SERVICE LETTER

No. 770

Piper Aircraft Corporation

Subject: Aileron Sprocket/Chain Inspection.

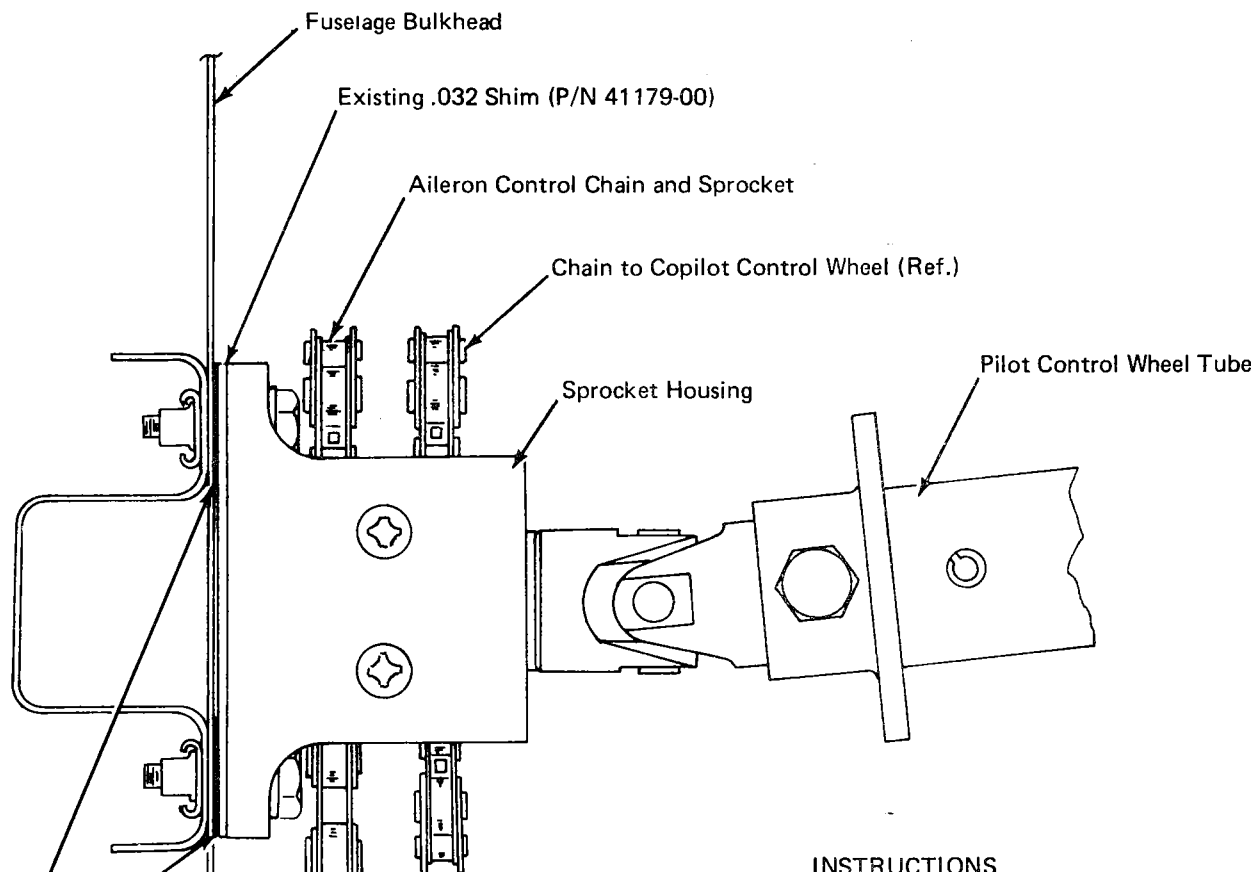
Add new .012 shim (P/N 55817-02) as req. to attain proper vertical alignment of sprocket and aileron control chain.

- a. Inspect at outboard end of sprocket housing to determine if the .032 shim (P/N 41179-00) is installed between the offset in the housing and the bulkhead. Install shim (P/N 41179-00) if it is not present. This shim will ensure proper horizontal alignment.

- b. To attain proper vertical alignment, install new .012 shims (P/N 55817-02) between the top or bottom of the sprocket housing and the bulkhead, as required, to ensure a smooth flow of the chain links over the sprocket.
